BELMONT MIDDLE AND HIGH SCHOOL BUILDING COMMITTEE

SEPTEMBER 11 2019

UPDATED EXTERIOR VE ITEMS

SITE IMPROVEMENTS - REDUCE EXCESS SOIL DISPOSALS BY RAISING GRADES

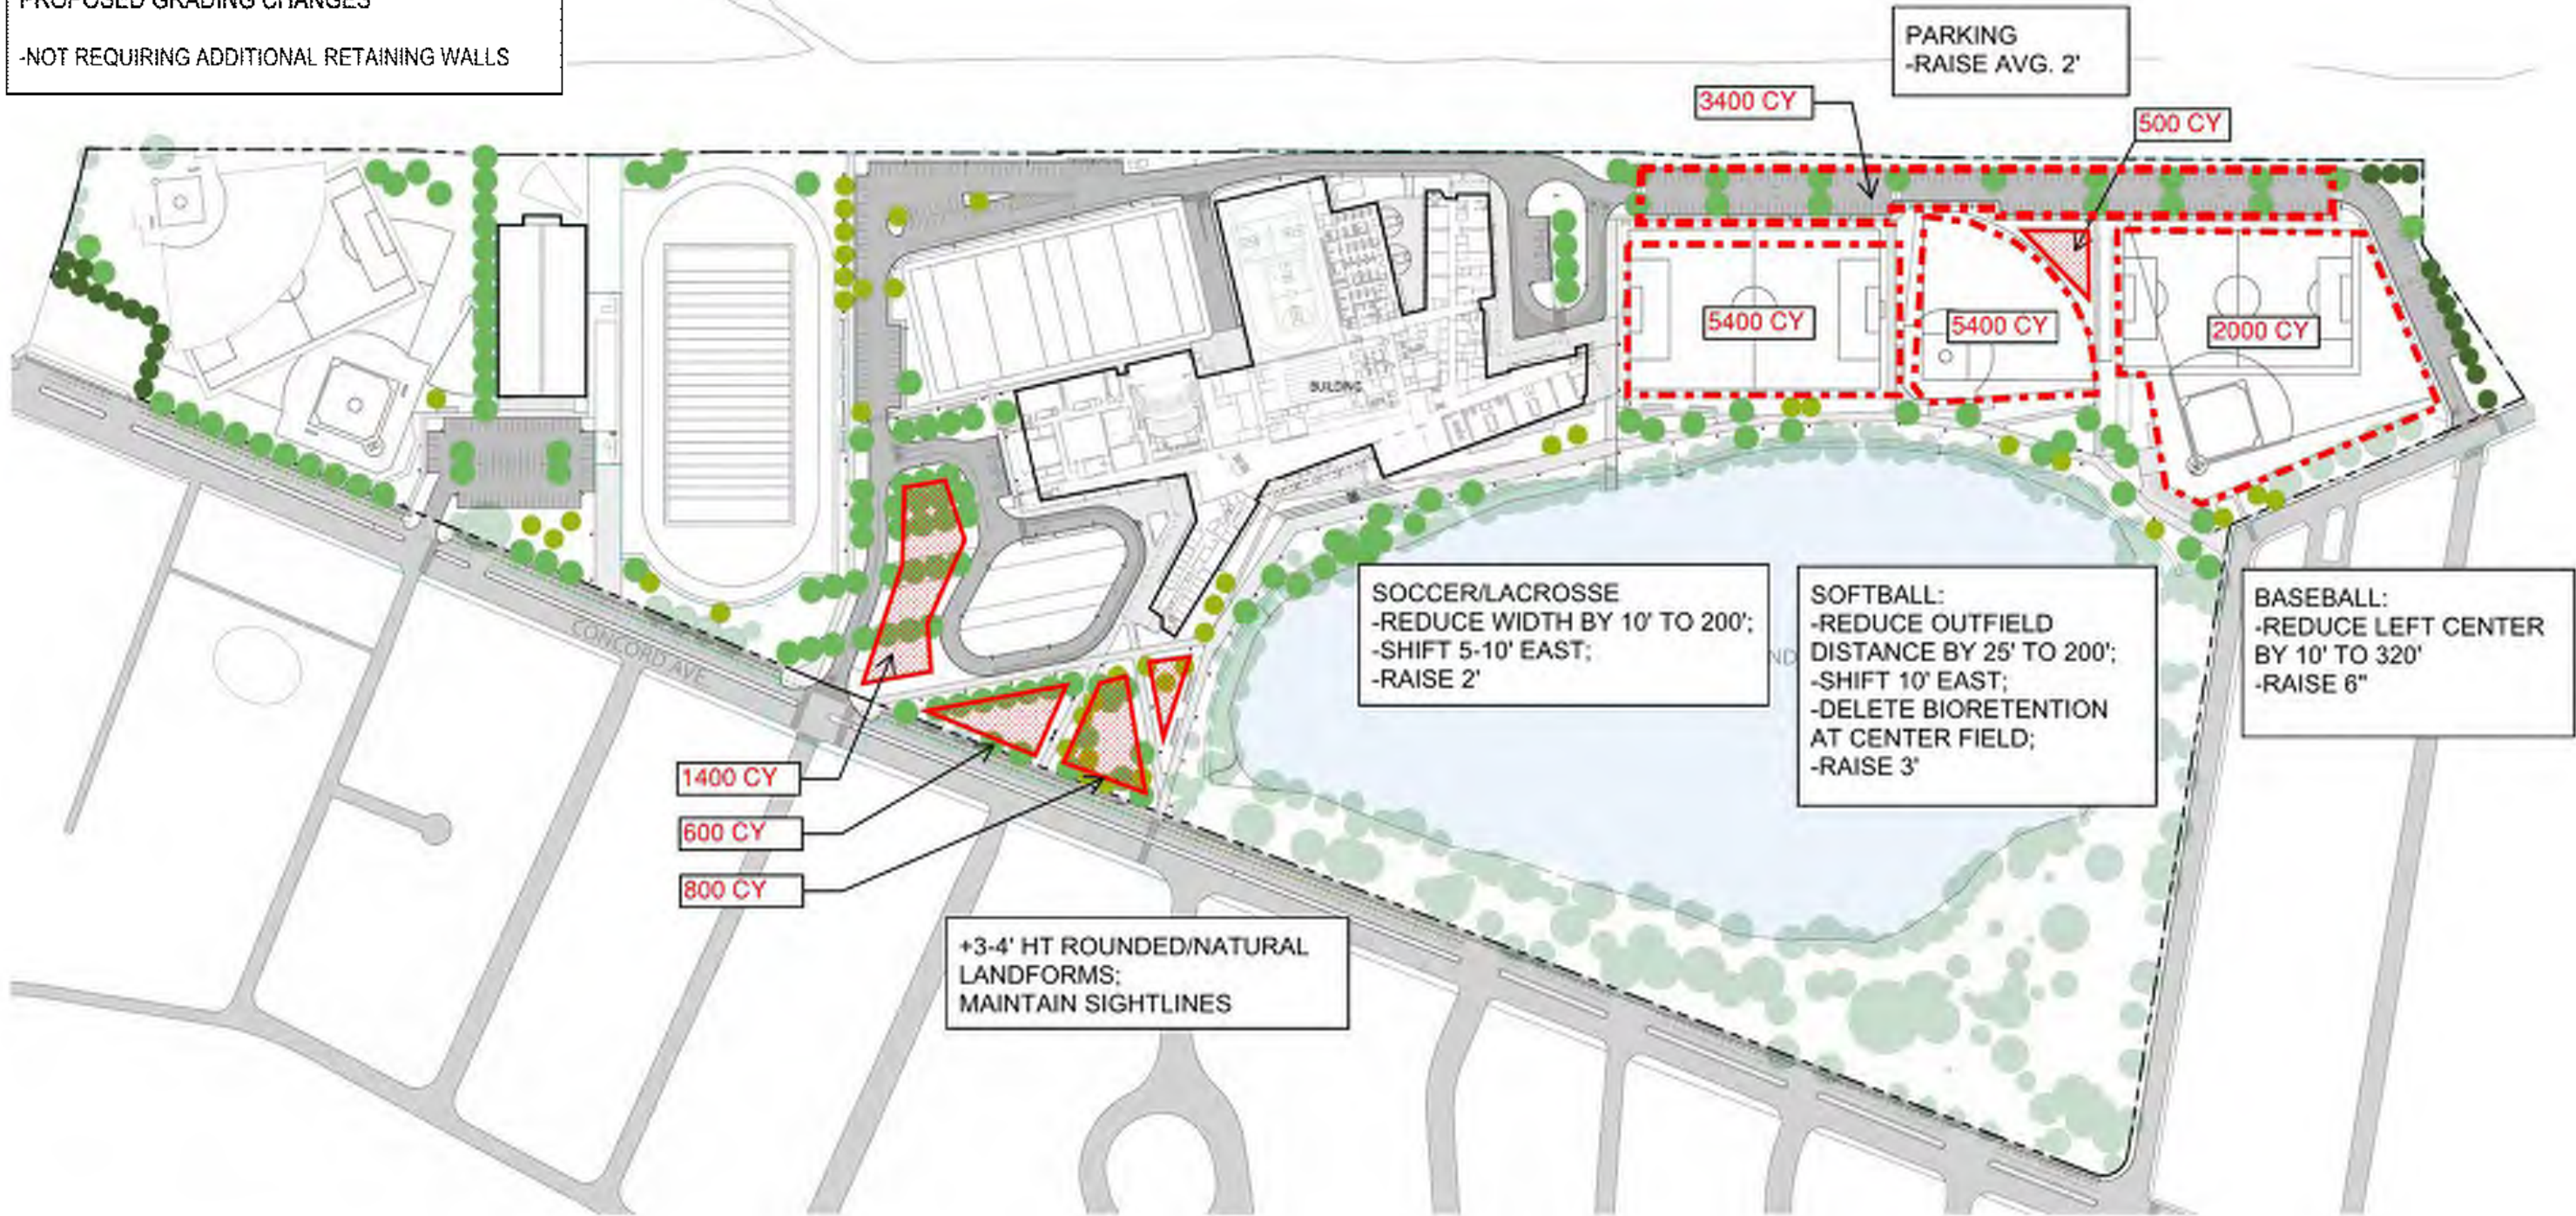
PROPOSED GRADING CHANGES
 -NOT REQUIRING ADDITIONAL RETAINING WALLS

SITE IMPROVEMENTS - REDUCE EXCESS SOIL DISPOSALS BY RAISING GRADES

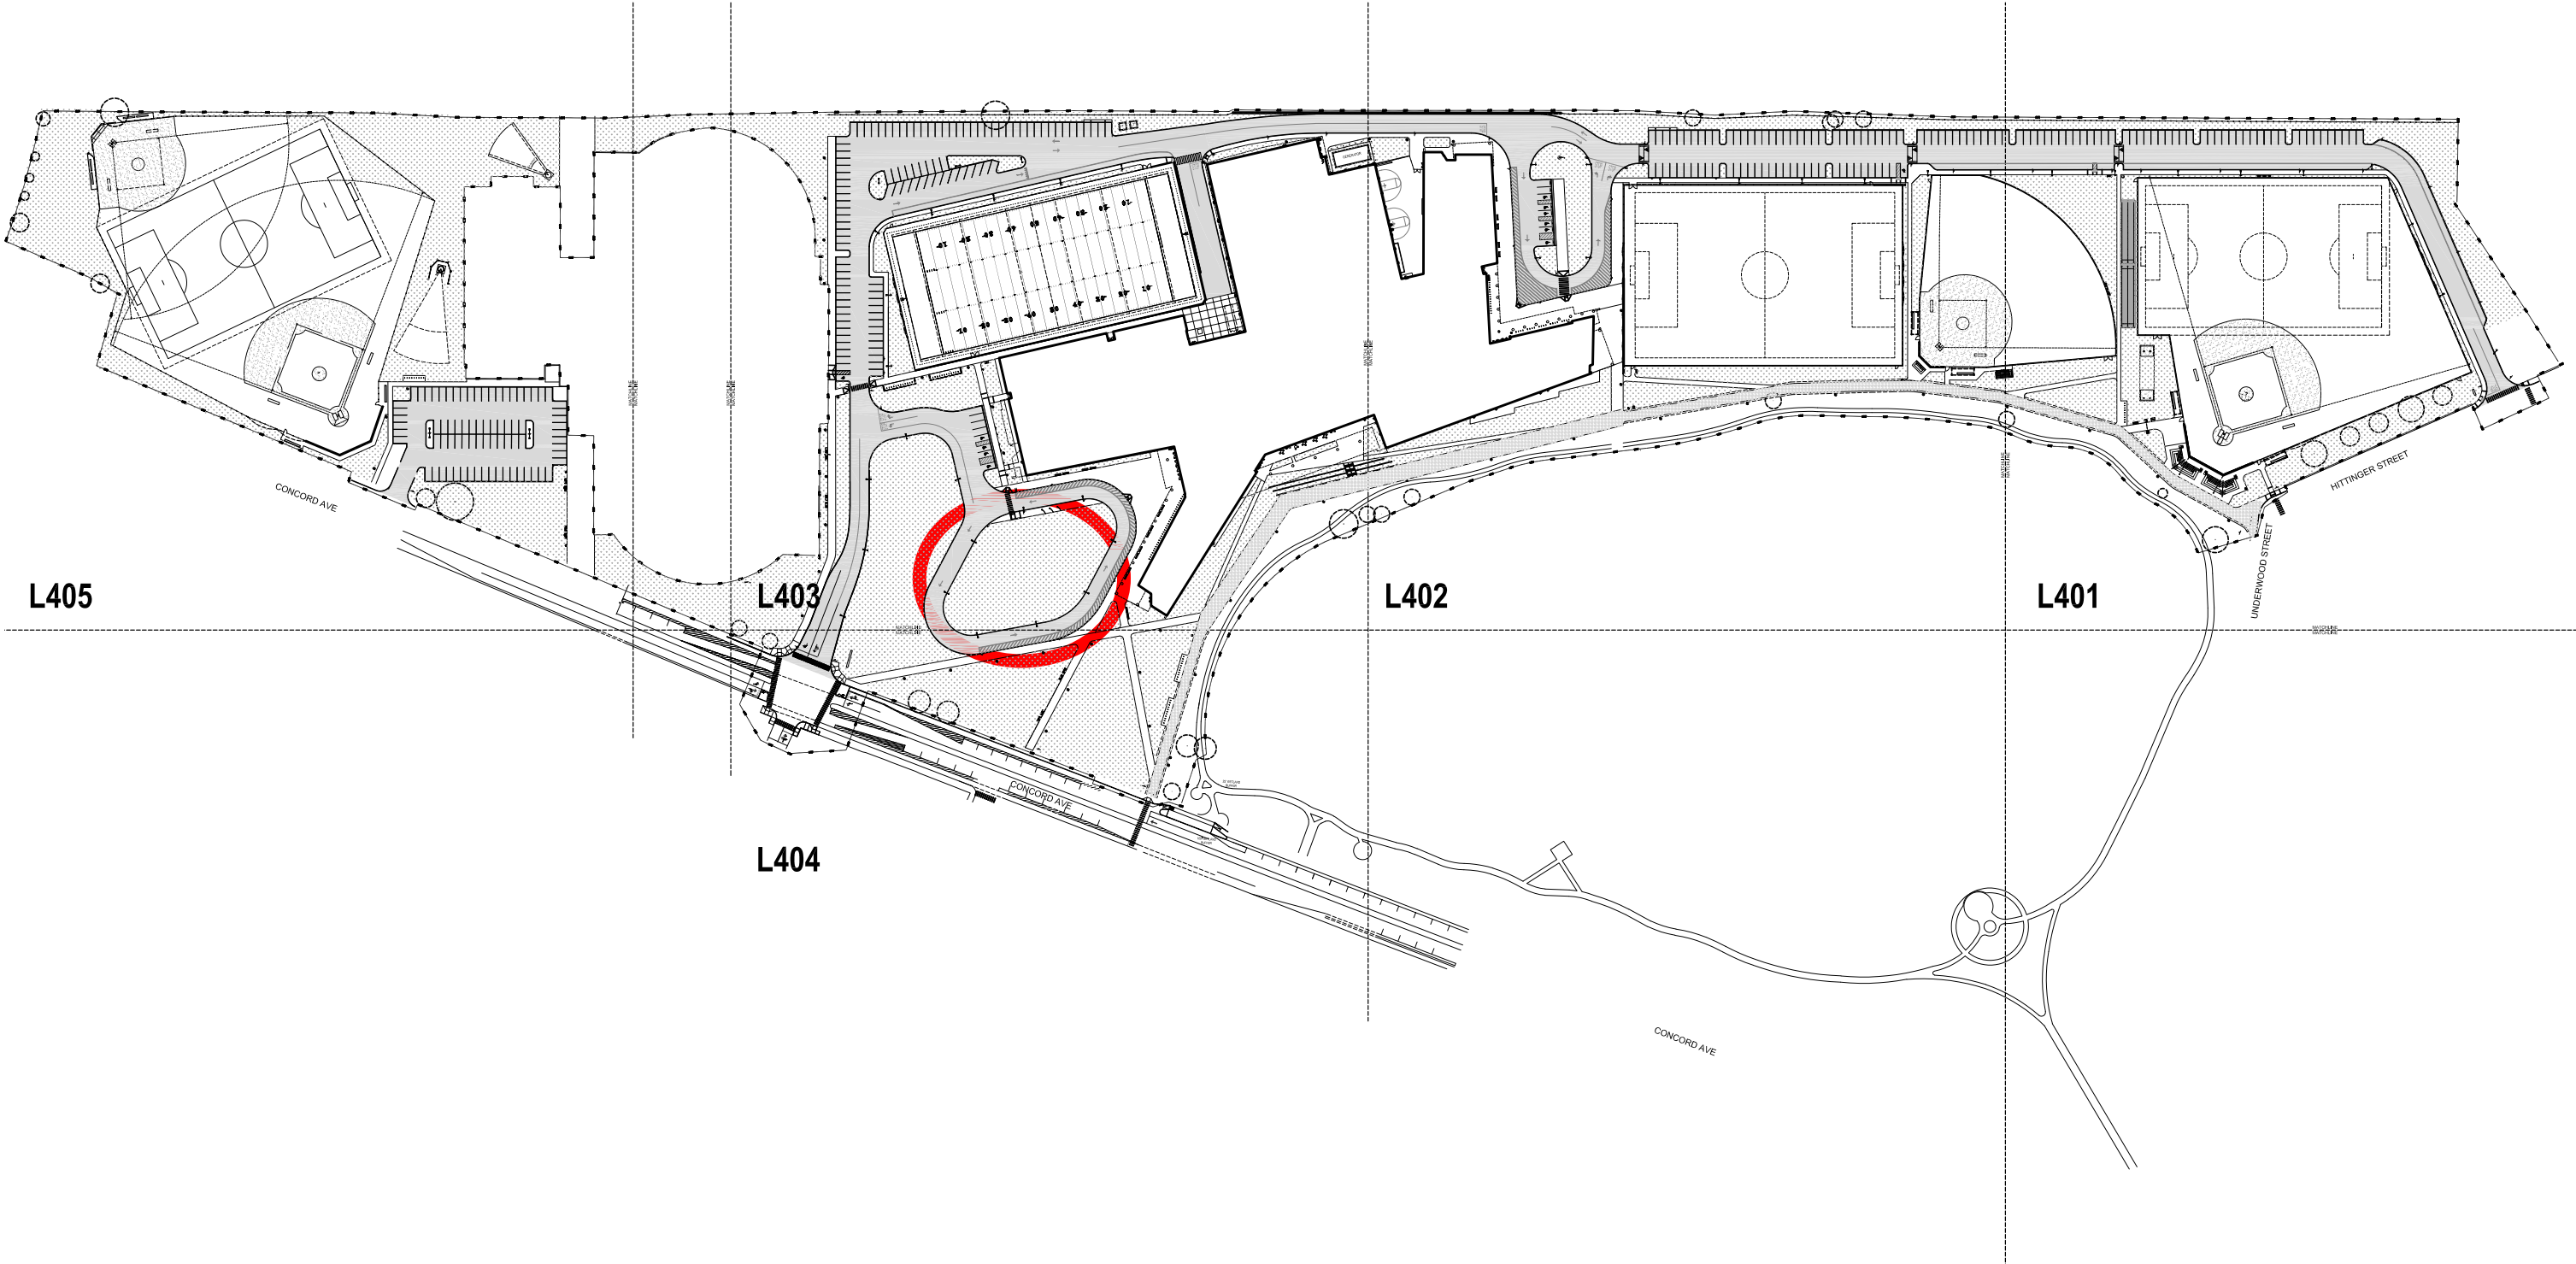
POTENTIAL GRADING CHANGES	elev change (+)	dimensional change		EXISTING	CURRENT DESIGN	9/10/2019
			CY			
PHASE 1						
LANDSCAPE BERMS AT CONCORD	UP TO 3.5'		2800			
PHASE 2						
SOCCER/LACROSSE	2'	10' NARROWER	5400	NONE	210X330	200X330
SOFTBALL	3'	15' SHORTER OUTFIELD	5400	250'	225'	200'-210'
BIORETENTION DELETE	N/A	N/A	500			
BASEBALL*	6"	10' SHORTER IN LEFT CENTER	2000	300'-320'	330'	320'
BASEBALL - OVERLAPPING SOCCER	NONE	10' NARROWER	N/A	NONE	180X300	170X300'
NORTH PARKING	2'		3400			
TOTAL			19500

*a shorter baseball outfield allows the north parking area to be raised
